Expedited System Impact Assessment Report

Bruce Power Inc.

Bruce B Standby Generator G5 to G8 AVR Replacements

CAA ID Number: 2006-EX295

Figure 2: Open Circuit Response

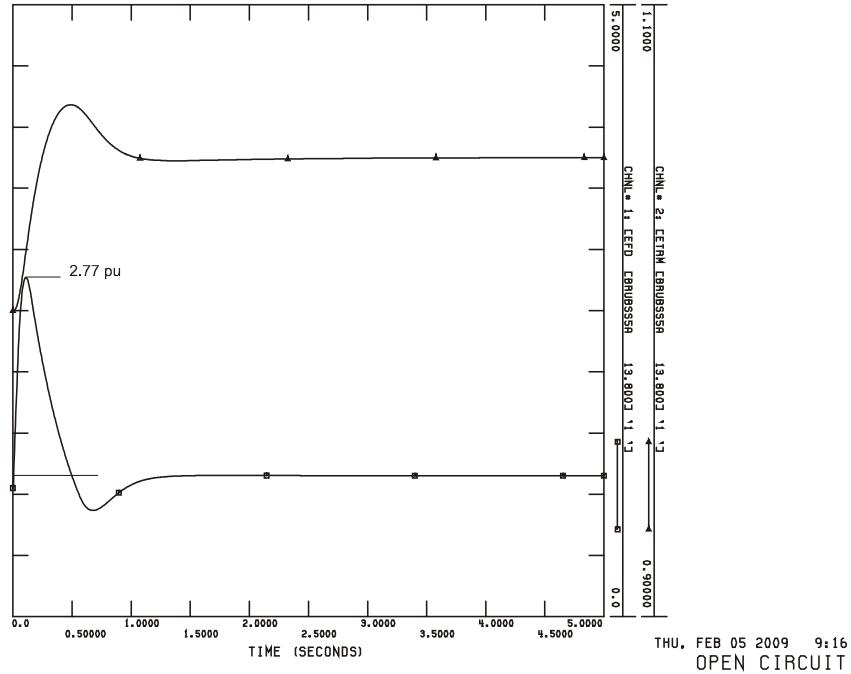
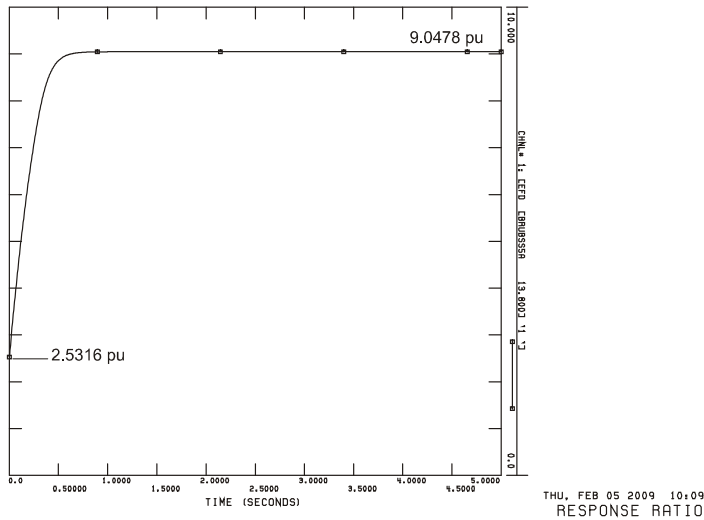
The IESO requires that the exciter have the capability of attaining $2xE_{fd_{rated}}$ on the open circuit test. Simulations show that $E_{fd_{rated}}$ is approximately 2.53 pu. Therefore, the exciter should have a capability of attaining $2 \times 2.53 = 5.06$ pu.

Figure 2 shows the exciter's response to a 5% step change in reference voltage for an open circuit test. As shown, a field voltage ceiling of 2.77 pu is reached; therefore, the exciter does not meet the standard Market Rule requirements.

Figure 4: Response Ratio – Nominal Response

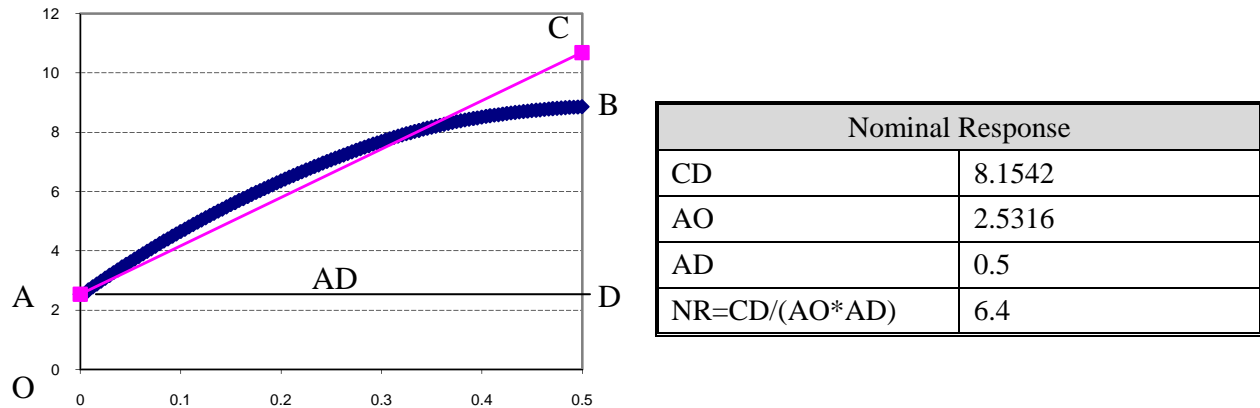
As shown from the calculations below, the nominal response is 6.44. The exciter meets the Market Rule requirement of a nominal response of at least 0.5.

In the technical data that Bruce has sent for the existing excitation system, the exciter response ratio is listed as 1.0. Therefore, it is expected that the new AVR will result in an improved nominal response.

Therefore, the modified exciter meets the lesser Market Rule requirements as demonstrated by the response ratio test.
